CHATSWOOD TO SYDENHAM
**CENTRAL WALK
MODIFICATION
SUBMISSIONS REPORT**

Executive summary

Transport for NSW is seeking to modify the approved project in relation to proposed changes at Central Station in accordance with section 115ZI of the EP&A Act. A modification report was lodged with the Department of Planning and Environment and publically exhibited from 21 June 2017 to 2 August 2017.

Figure 2-1a Pedestrian movement Phase 1

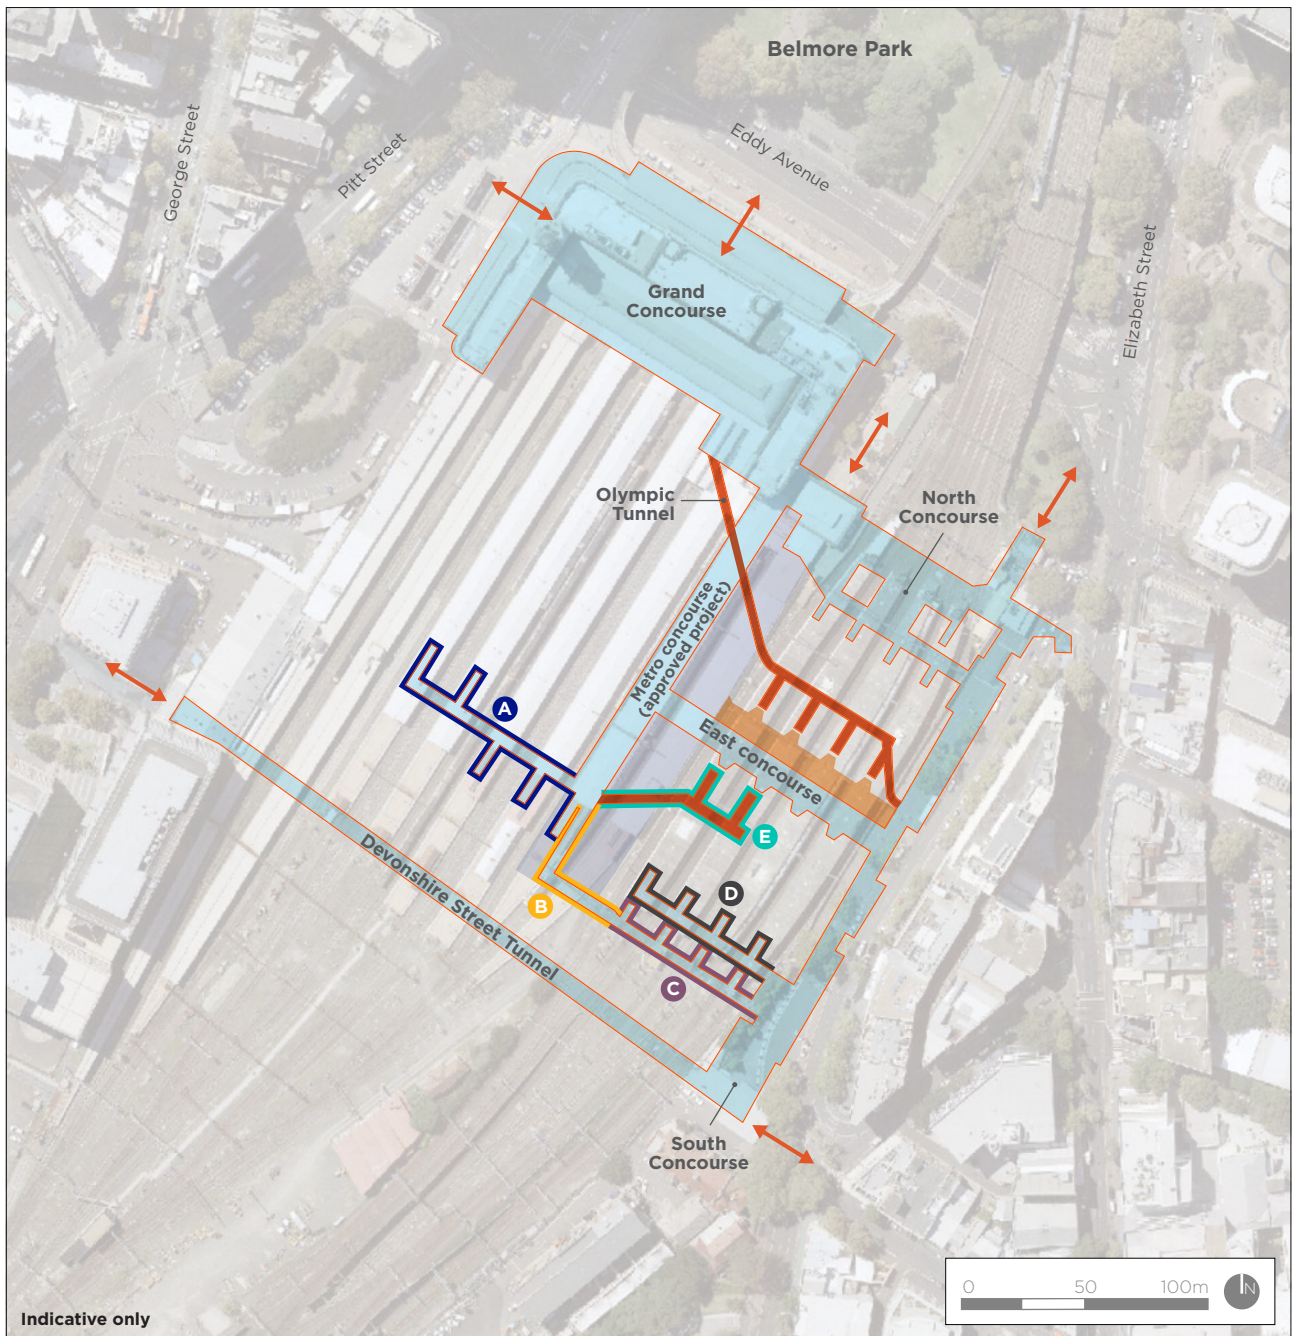
Section 7.8.7 of the modification report provided a description of how pedestrian flows within Central Station would be phased during construction to maintain connectivity and minimise disruption. This description of pedestrian phases was correct, however there were some omissions on the associated figures in the printed versions of the document.
